NATIONAL CAPITAL AUTHORITY

AMENDMENT 29  
(KINGSTON FORESHORE)

APRIL 2000

## AMENDMENT 29 OF THE NATIONAL CAPITAL PLAN

Figure 3

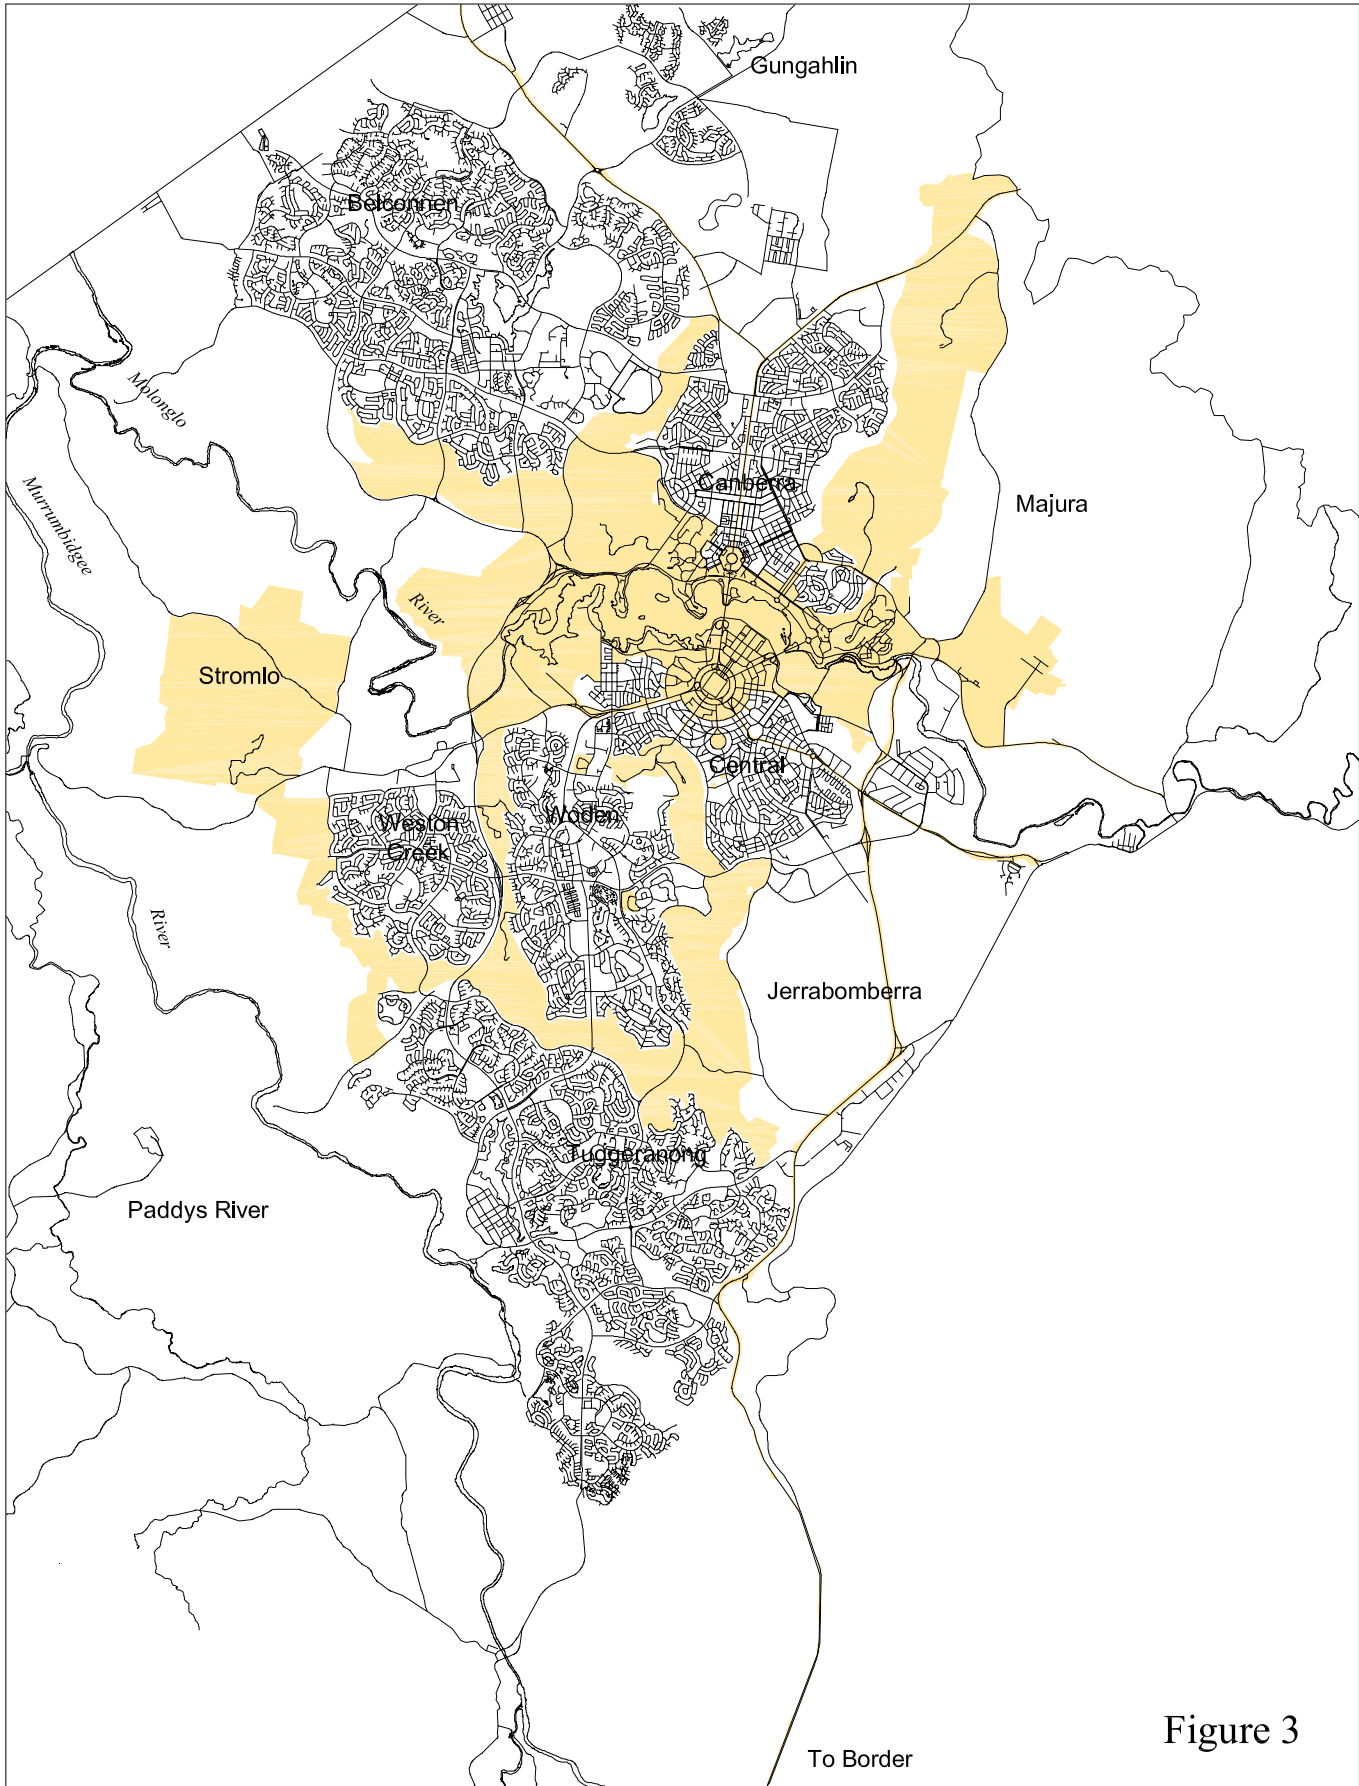
1. WITHDRAWING Figure 1 entitled “General Policy Plan - Metropolitan Canberra” and REPLACING it with the amended Figure 1 at Attachment A.
2. WITHDRAWING “Figure 3 - Designated Areas” and REPLACING it with the amended Figure 3 at Attachment B.

Figure 17  
**The Central National Area  
 (Lake Burley Griffin and Foreshores)**

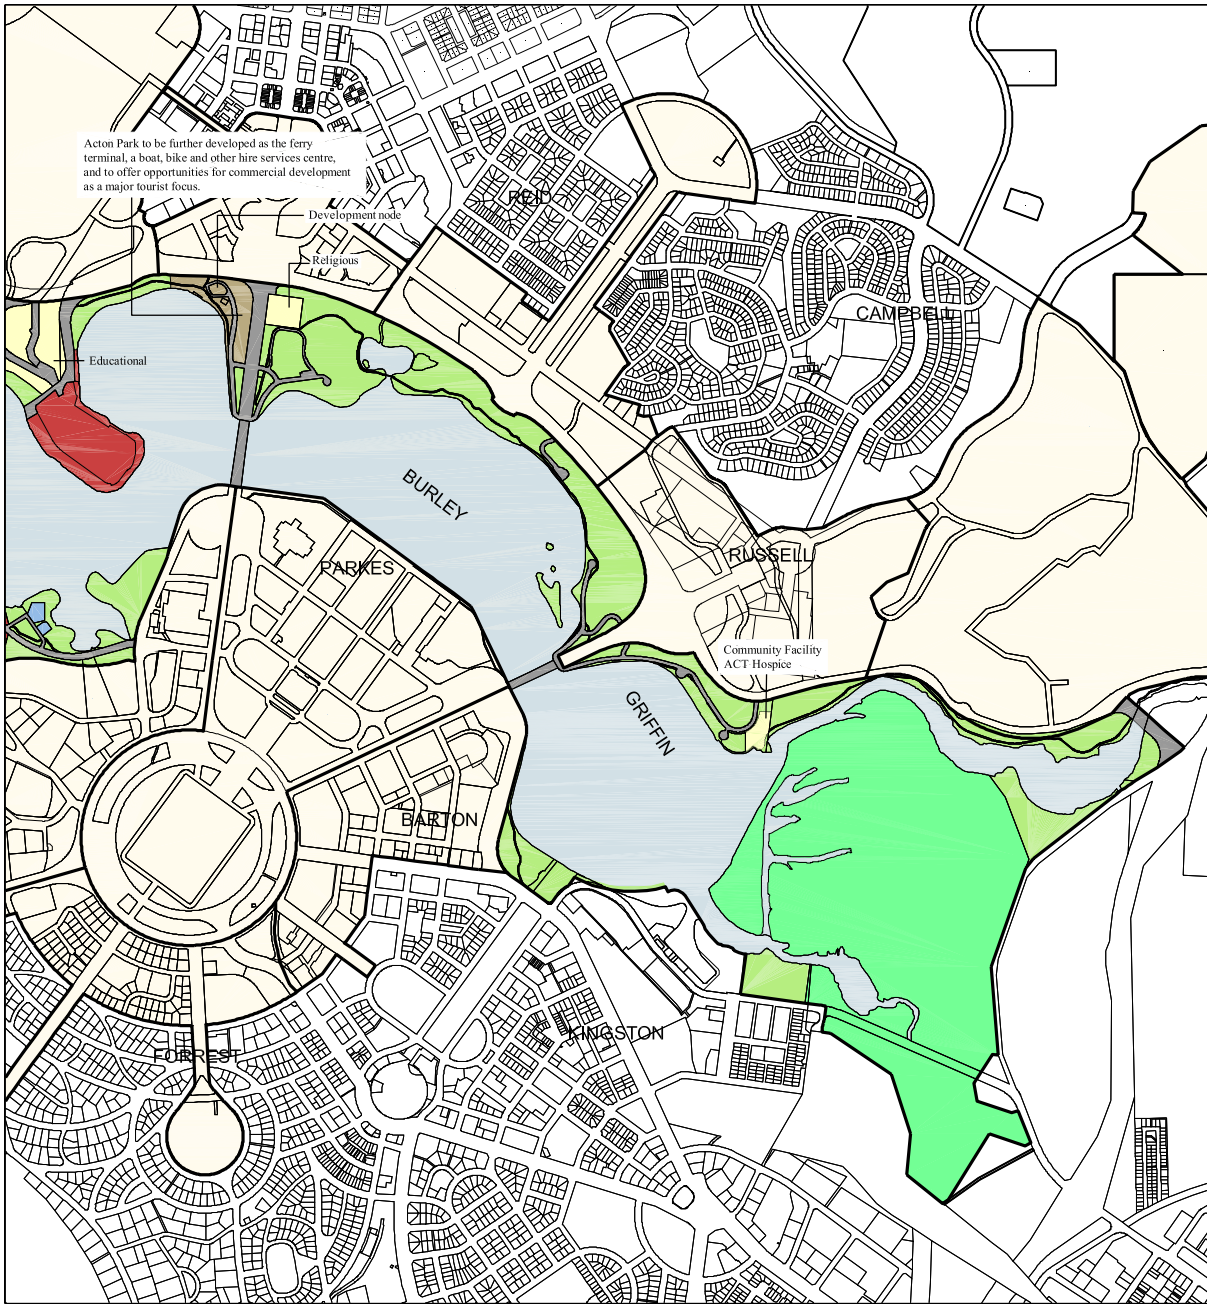
3. WITHDRAWING the second page of “Figure 17 – The Central National Area (Lake Burley Griffin and Foreshores)” and REPLACING it with the amended second page of Figure 17 at Attachment C, and DELETING the words “*Lake maintenance and boat servicing in Kingston Boat Harbour, and*” from Note B which follows and forms part of Figure 17.

Figure 18

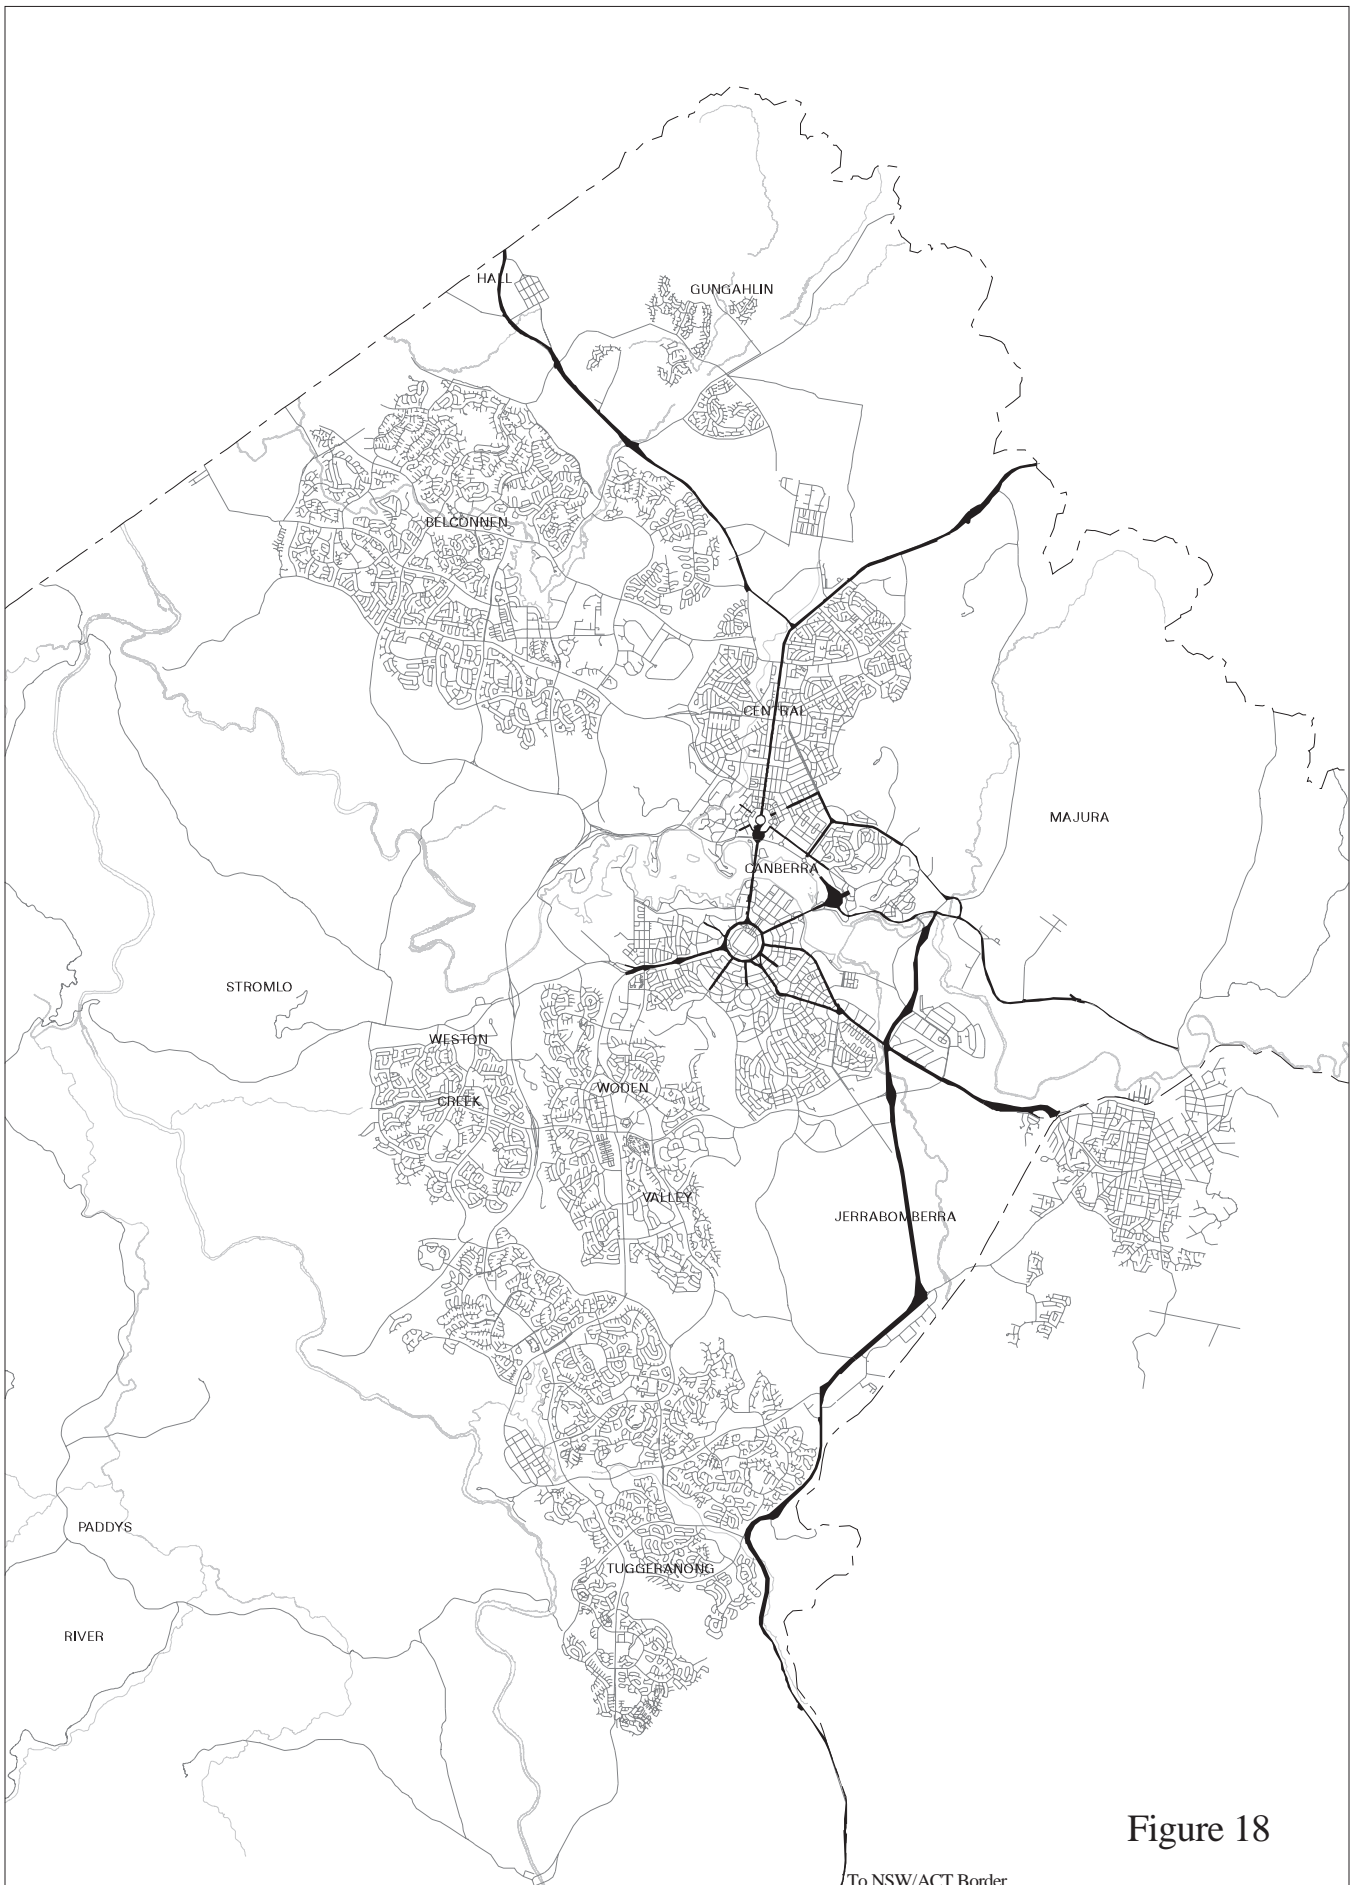
4. WITHDRAWING “Figure 18 – Main Avenues and Approach Routes” and REPLACING it with the amended Figure 18 at Attachment D.
5. DELETING “Wentworth Avenue” from the schedule of Main Avenues set out at 2.1 and “Wentworth Avenue, from Hume Circle to Brisbane Avenue” from the schedule of Main Avenues at 2.3.

Figure 20

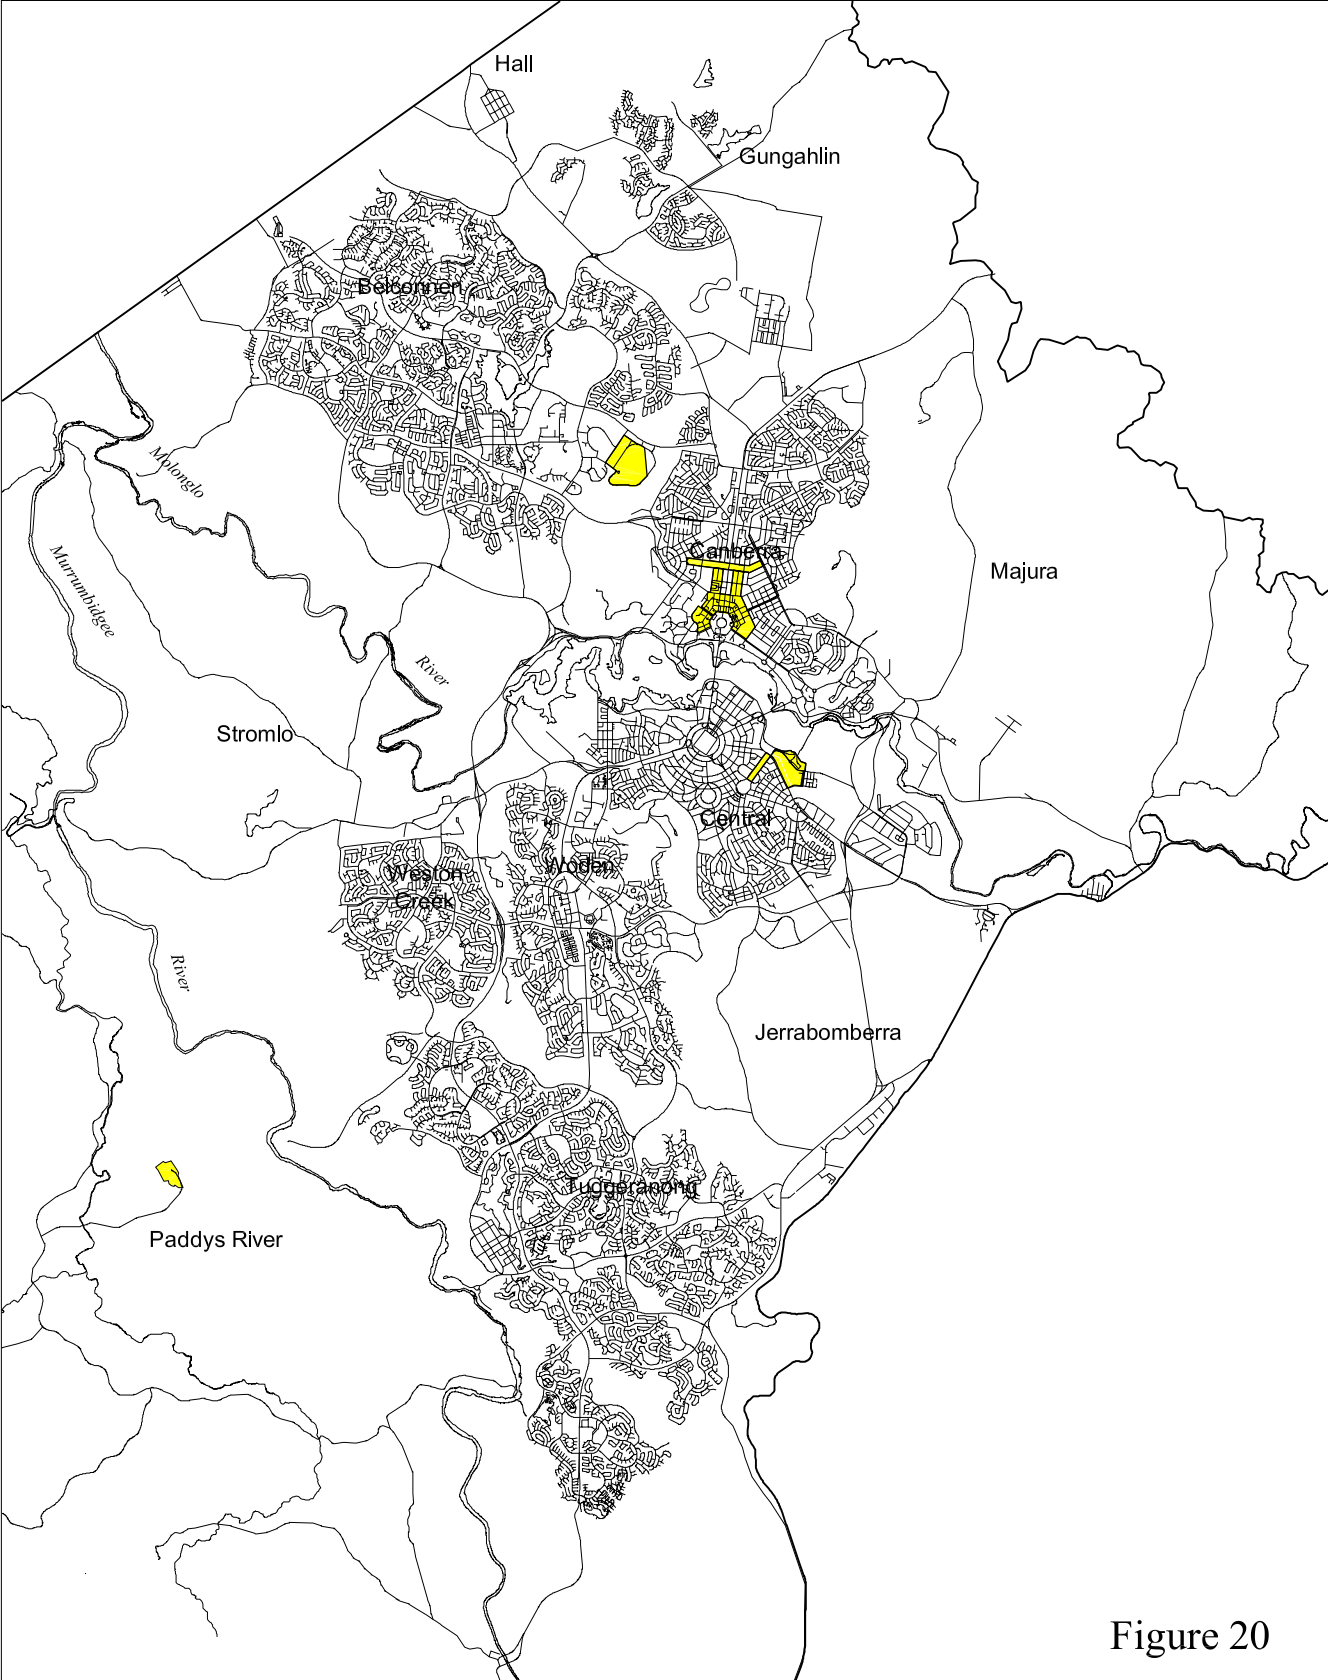
6. WITHDRAWING “Figure 20 – Special Requirements” and REPLACING it with the amended Figure 20 at Attachment E.
7. WITHDRAWING the second page of “Figure 4 – The Central National Area (Key Map)” and replacing it with the amended second page of Figure 4 at Attachment F.
